# PLAN COMMISSION STAFF REPORT

**Agenda Item:** PC 26-001

**Application Type:** Development Plan Review

**Summary:** The Laborers International Union of North America Local 41, is requesting Development Plan Approval for a second-story addition to an existing one-story brick union hall building located at 550 Superior Avenue

**Building Renderings/Elevation:**

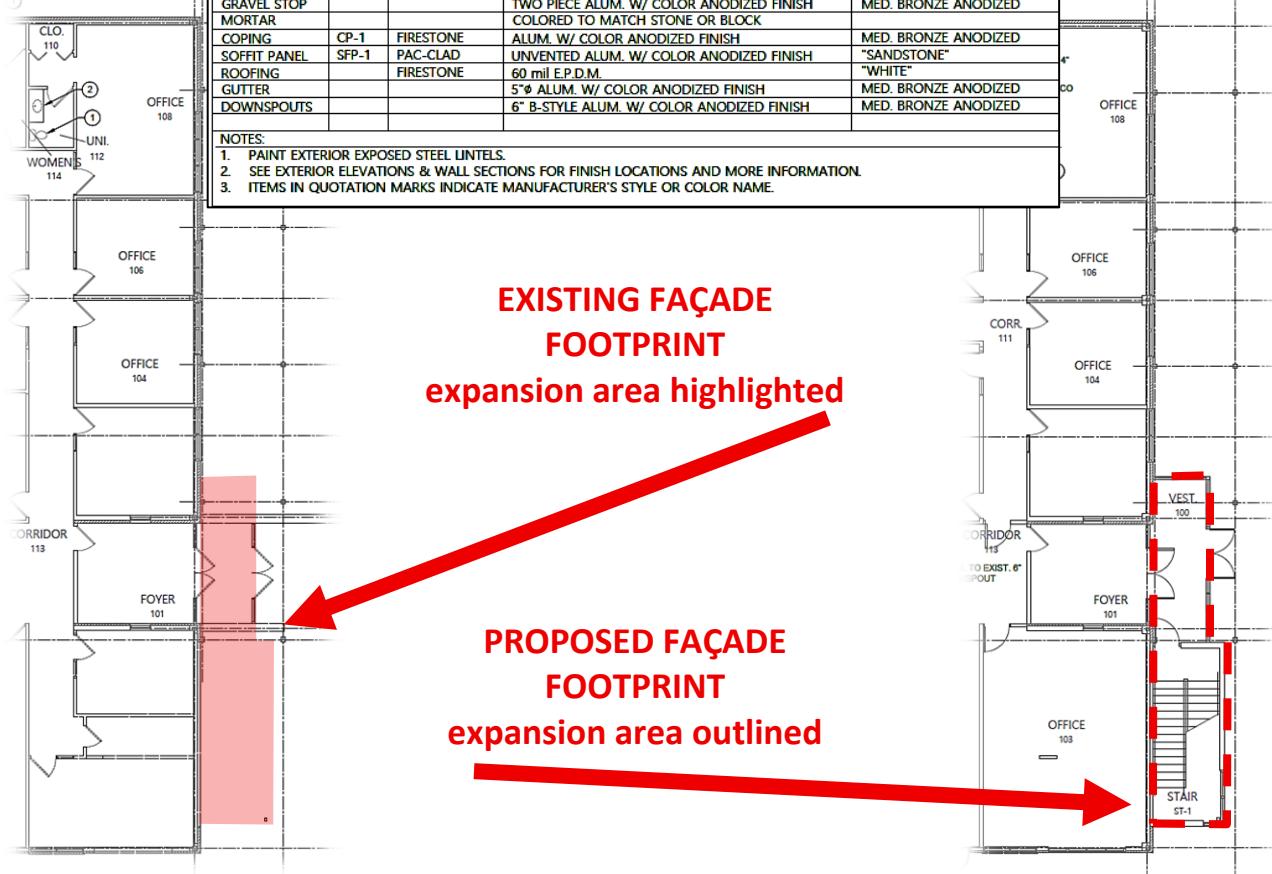
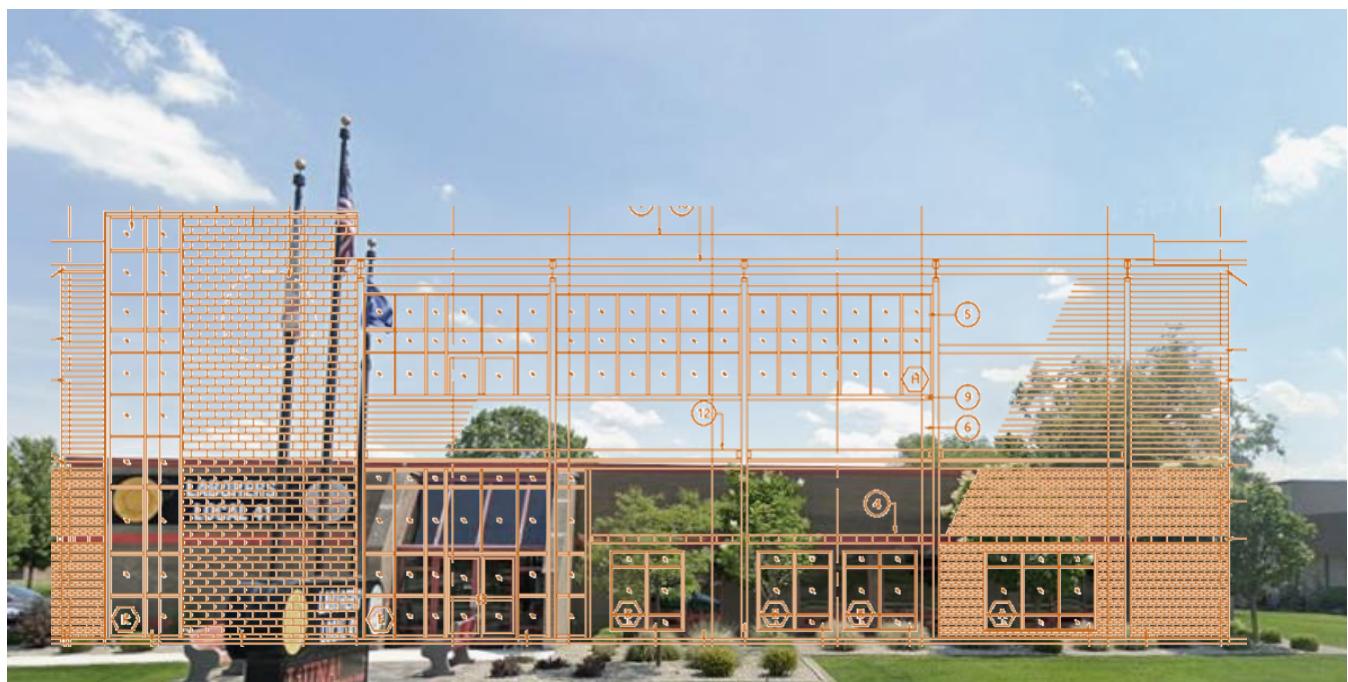
Staff finds that the proposed building material for the second-story addition constructed of glass, composite wood, and masonry block unit façade is visually consistent with existing commercial construction standards and complements the character of the area and would encourage the commissioners to accept the proposed masonry units as "similar" and complimentary to the existing and surrounding buildings. It is staff's belief that the proposed elevation enhancements maintain the architecture of the existing building envelope with a modern updated appearance.

*Motion to APPROVE PC 26-001, a proposed Development Plan for a second-story addition and façade update with building materials as presented, including all discussion and findings, with the condition that the applicant comply with the Town's tree placement standards and all lighting and signage codes, or seek a variance from the Board of Zoning Appeals.*
